**MODELS**      LC26D44E                      LC32D44E

**Sharp Electronics (UK) Limited**

Reference – LV278

**Figure 1: Location of R8408.**

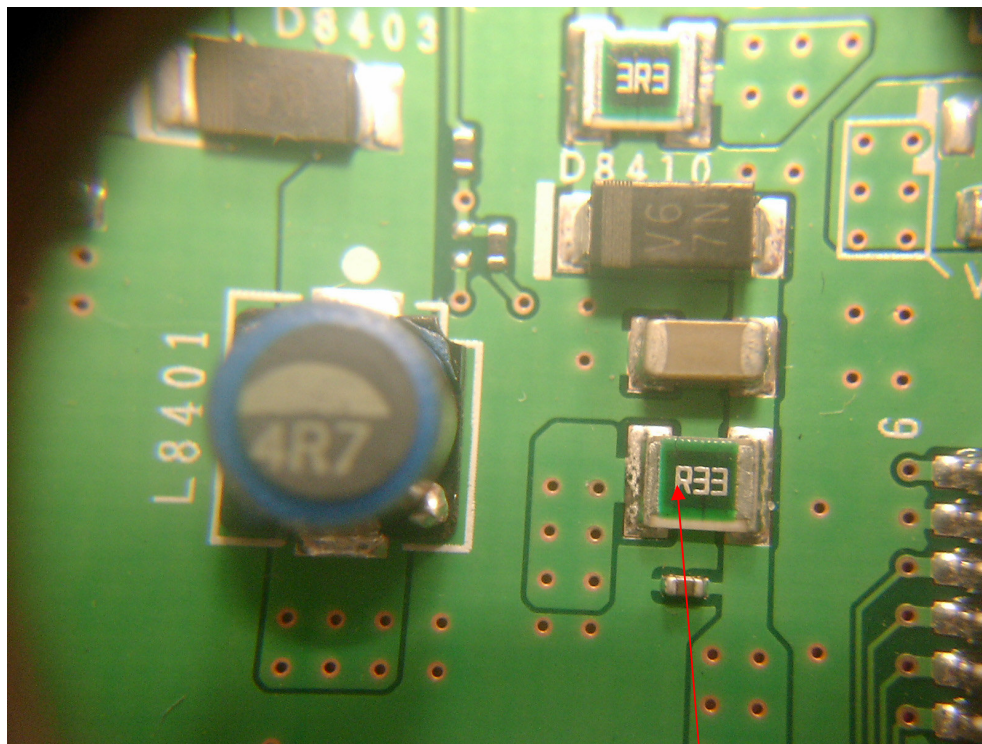
**SYMPTOM**    No function or backlight, green LED on.

**CAUSE**        R8408 high resistance/cracked.

**ACTION**        Check the value of R8408 and if high replace.

<b><u>REF NO</u></b>	<b><u>DESCRIPTION</u></b>	<b><u>PART NUMBER</u></b>	<b><u>PRICE CODE</u></b>
R8408	SMD Resistor, 0.33Ω	VRS-TW2HPR33JY	AA
